SOLICITATION AMENDMENT
MODIFICATION DE L'INVITATION

Title - Sujet Pumps, Fabricate & Install	
Solicitation No. - N° de l'invitation F1700-130425/A	Amendment No. - N° modif. 002
Client Reference No. - N° de référence du client F1700-130425	Date 2013-08-14
GETS Reference No. - N° de référence de SEAG PW-\$VAN-585-7056	
File No. - N° de dossier VAN-3-36095 (585)	CCC No./N° CCC - FMS No./N° VME
Solicitation Closes - L'invitation prend fin at - à 02:00 PM on - le 2013-09-09	Time Zone Fuseau horaire Pacific Daylight Saving Time PDT
F.O.B. - F.A.B. Plant-Usine: <input type="checkbox"/> Destination: <input type="checkbox"/> Other-Autre: <input type="checkbox"/>	
Address Enquiries to: - Adresser toutes questions à: Mak, Goretti M.	Buyer Id - Id de l'acheteur van585
Telephone No. - N° de téléphone (604) 775-7649 ()	FAX No. - N° de FAX (604) 775-7526
Destination - of Goods, Services, and Construction: Destination - des biens, services et construction:

Amendment #2 - F1700-130425/A

SECTION
C 3300

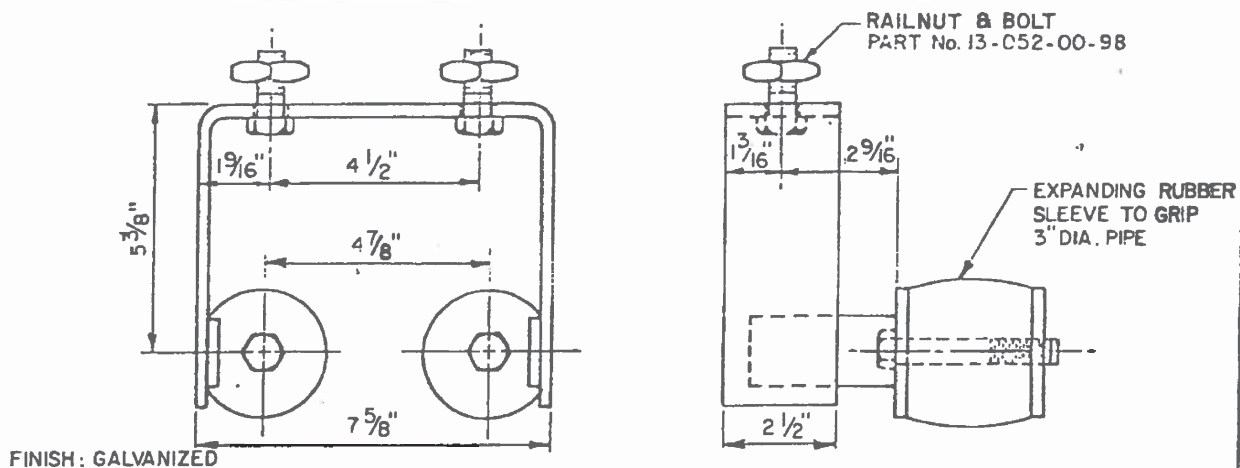
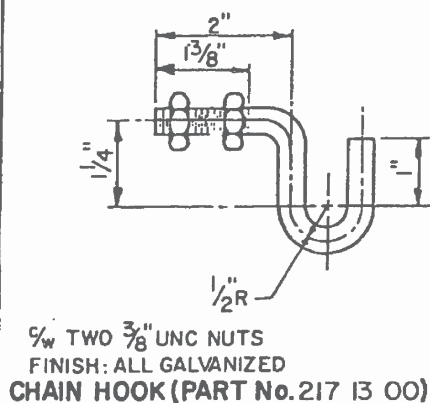
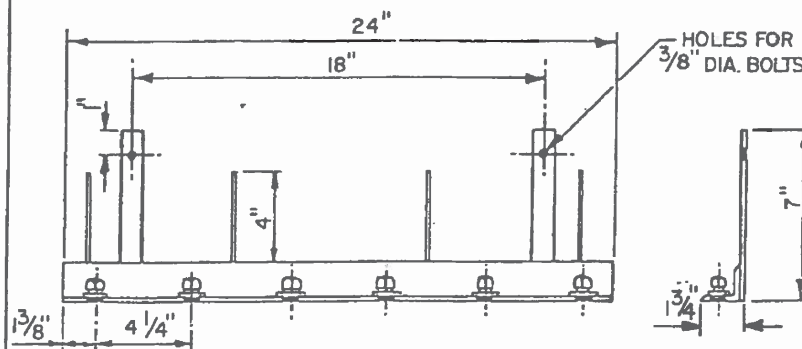
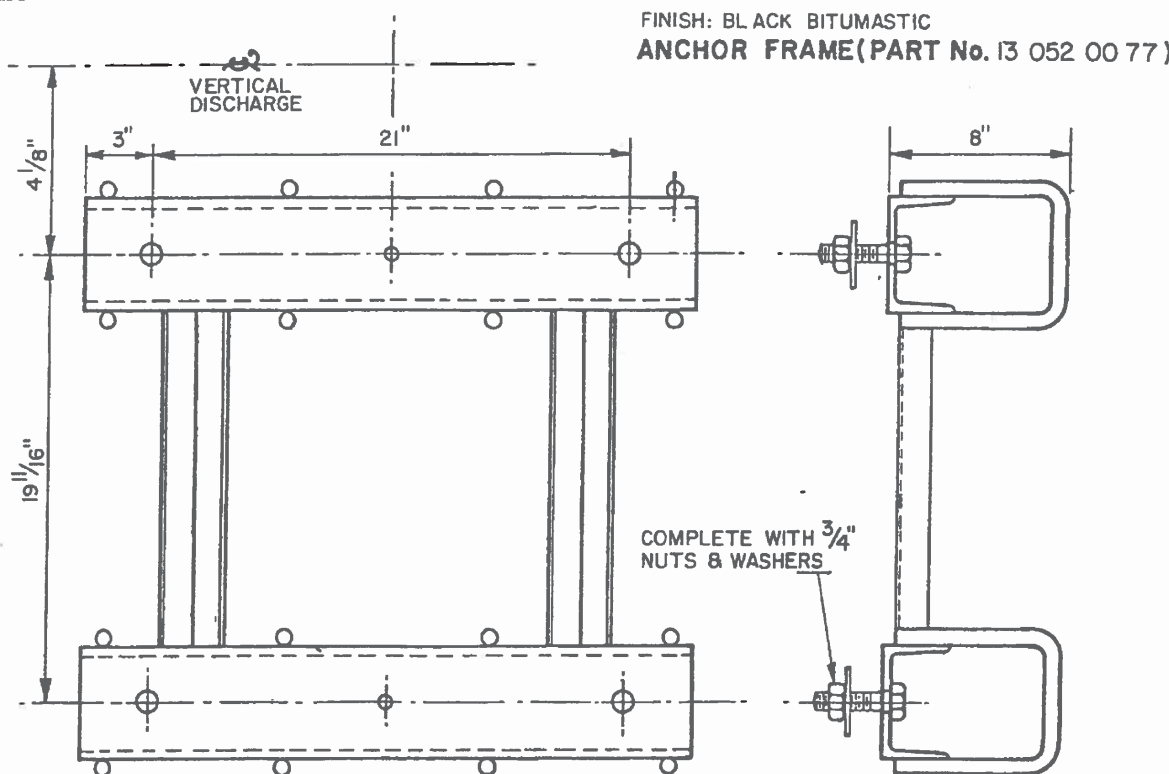
- Q1: Will alternative ABS pumps require adapters to the Flygt Guide Rail system or would a change to ABS Guide Rails be considered?
- R1: The new pumps, installation, and commissioning is part of this contract. Either adapters to the Flygt Guide Rail system or a change to a new rail system to fit the new pumps would be acceptable.

- Q3: Please confirm existing pumps guide rail size (diameter).
- R3: 3"
- Q4: Please confirm existing Flygt pump discharge size (diameter).
- R4: Dwg 22-35-267 shows pump discharge piping as 300 mm (12") and we will default to this pending confirmation. It is a 12" Flygt pump mounted on a 12" discharge connection. Please contact jodi.nelson@pwgsc.gc.ca for drawings.
